Addendum 33 – UN Regulation No. 34

Revision 2 - Amendment 7

04 series of amendments – Date of entry into force: 5 June 2023

Uniform provisions concerning the approval of vehicles with regard to the prevention of fire risks

Model A

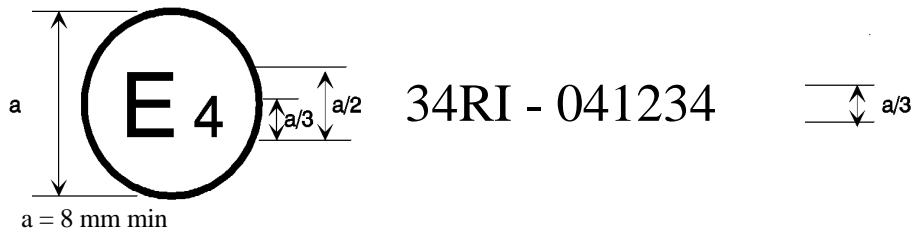
Annex 2, amend to read (footnote unchanged):

The above approval mark affixed to a vehicle shows that the type concerned was approved in the Netherlands (E4) pursuant to Part I of UN Regulation No. 34 under approval No. 041234. The first two digits (04) of the approval number indicate that the approval was granted in accordance with the requirements of UN Regulation No. 34 as amended by the 04 series of amendments."

Model E

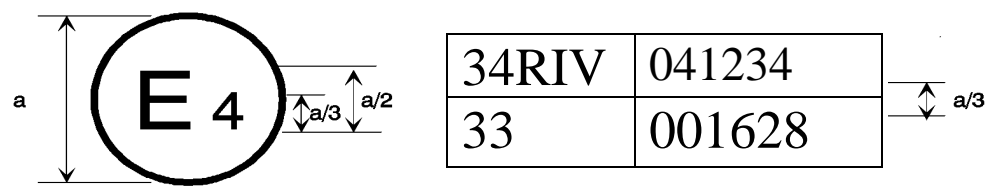
a = 8 mm min.

The above approval mark affixed to a vehicle shows that the type concerned was approved in the Netherlands (E4) pursuant to UN Regulations Nos. 34 Part IV and 33.* The approval numbers indicated that, at the date when the respective approvals were given, UN Regulation No. 34 included the 04 series of amendments and UN Regulation No. 33 was still in its original form."
